# EMERGENCY AIRWORTHINESS DIRECTIVE

**DATE: April 10, 2001**  
**2001-08-51**

## **2001-08-51 CFM International (CFMI): Docket No. 2001-NE-08-AD**

This emergency AD is applicable to CFM56-5C turbofan engines. These engines are installed on, but not limited to Airbus Industrie A340 airplanes.

**Q** POST SB 72-069

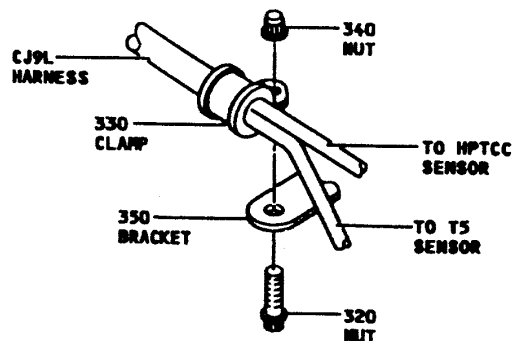
(4) Visually inspect the silicone material clamps for wear and harness looseness at details Q, R, and S as shown in Appendix 1 of this AD, and before further flight, replace clamps if worn or if harness is loose.

(c) Replacement of existing clamps (red and brown silicon) at details Q, R, and S of CJ9L harness with new clamps part numbers 649-412-351-0 and 649-412-354-0 constitutes terminating action for the repetitive inspection requirements of paragraph (b) of this AD.

**R**

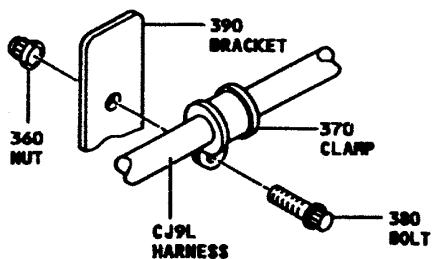
(3) Visually inspect and, if necessary, correct the bracket and clamp locations at details R and S of the CJ9L harness as shown in Appendix 1 of this AD, titled "Figure 401 of Airbus Maintenance Manual AMM ATA 73-21-50" in accordance with paragraphs 3 through 3.c. of AOW No. 01/CFM56/425, dated April 10, 2001.
